Open Report on behalf of Andy Gutherson - Executive Director for Place

Report to:	Planning and Regulation Committee
Date:	2 October 2023
Subject:	Application by Cottam Solar for a Development Consent Order to install solar PV panels to generate 530MW, on site battery storage with 600MW/h capacity and associated infrastructure including battery energy storage system, access provision and an underground 400kV electrical connection to the National Grid Substation at Cottam Power Station.

Figure 7.11
Cottam 1
Augmented ZTV

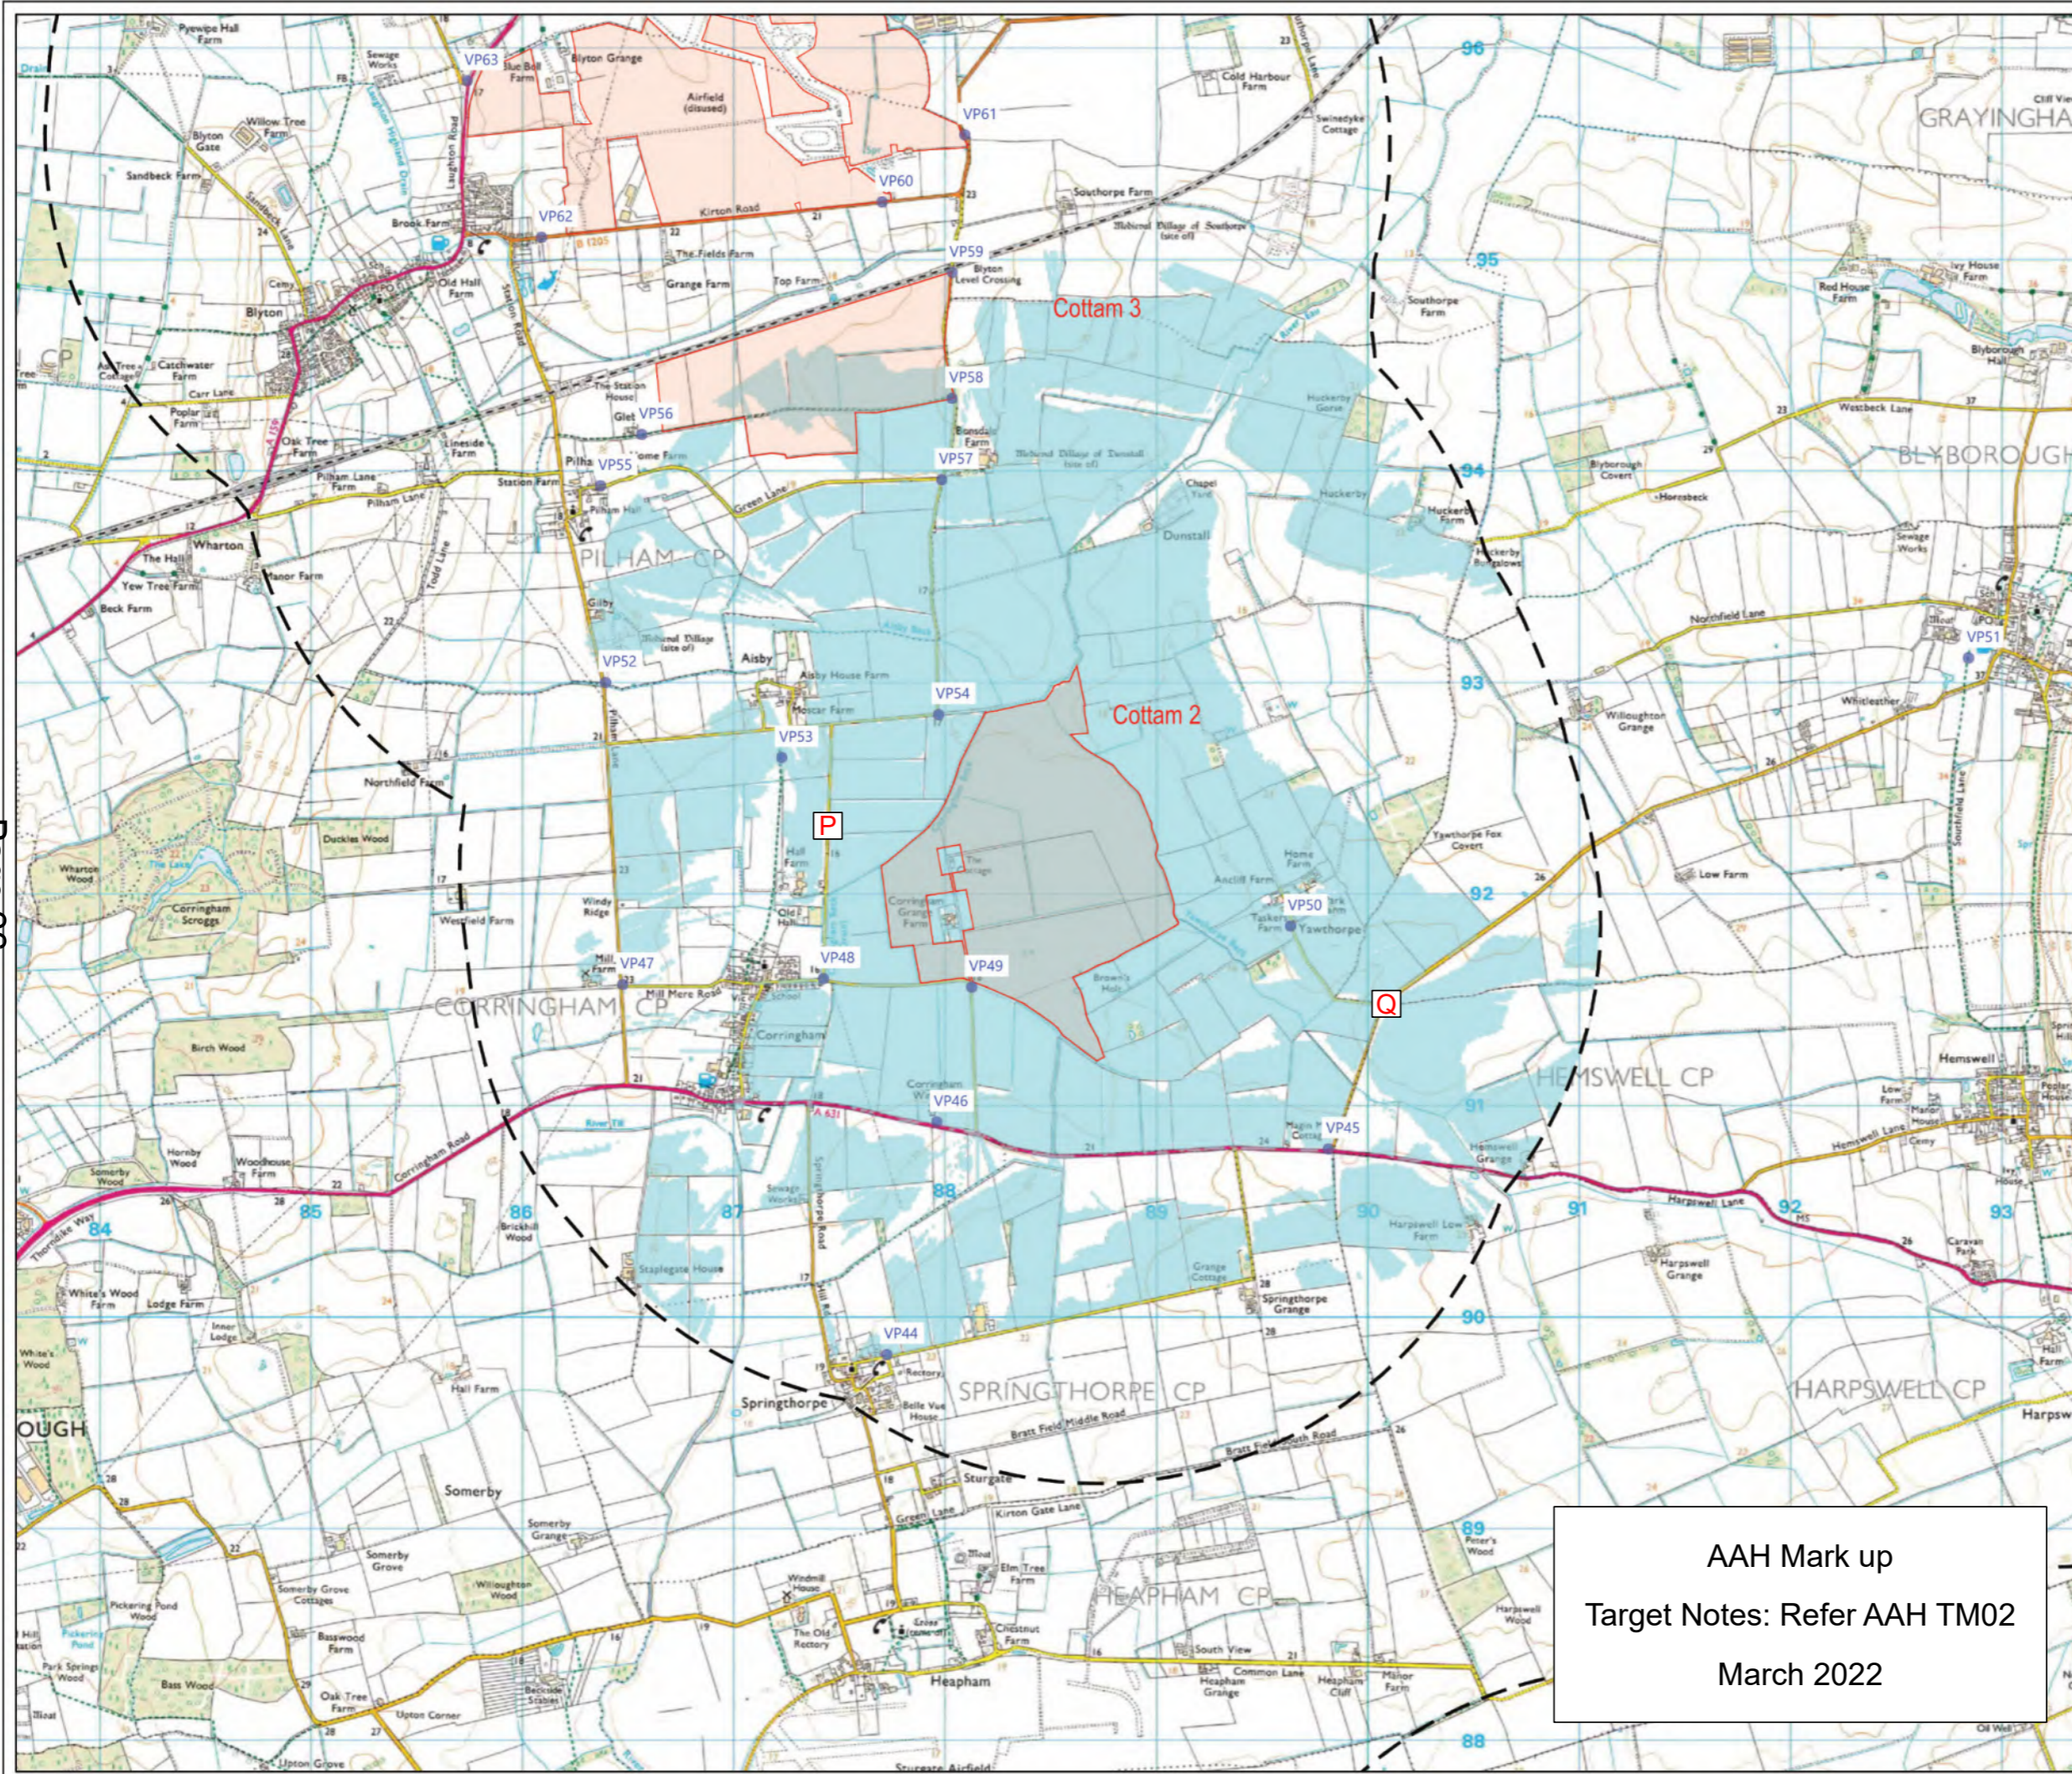
As shown on mark up Figure 7.11 Cottam 1 Augmented ZTV

Figure 7.12
Cottam 2
Augmented ZTV

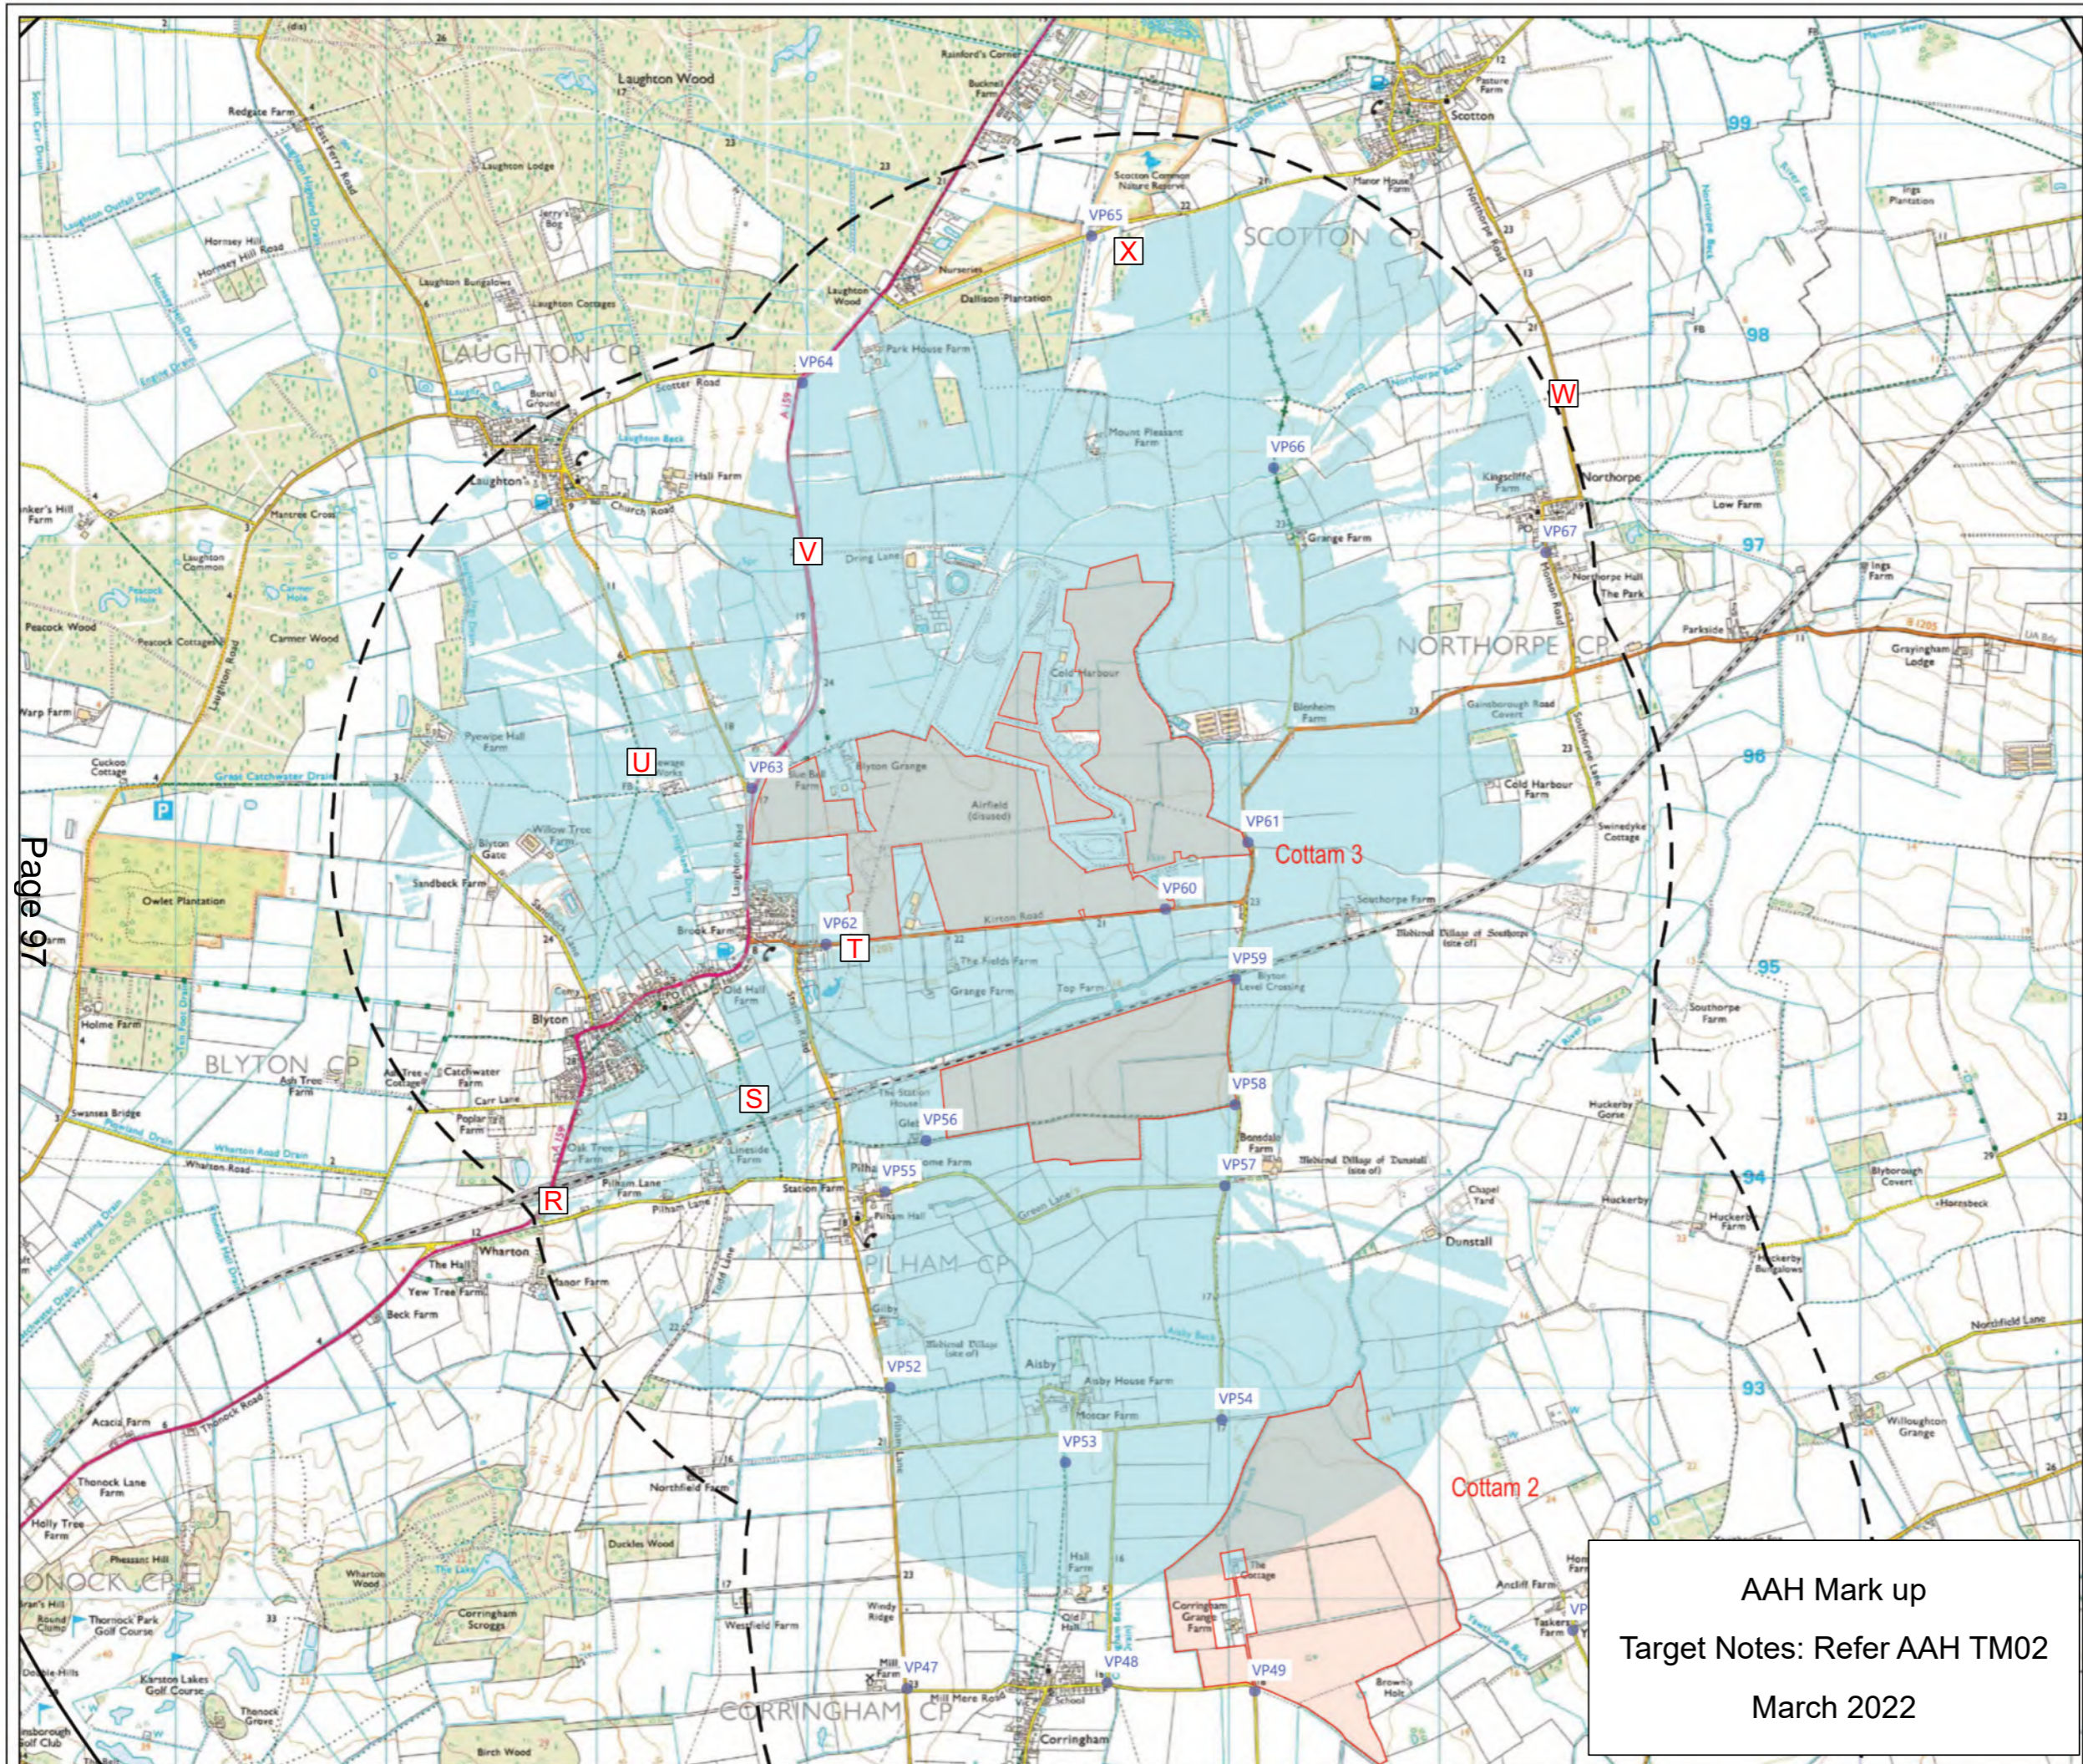
As shown on mark up Figure 7.12 Cottam 2 Augmented ZTV
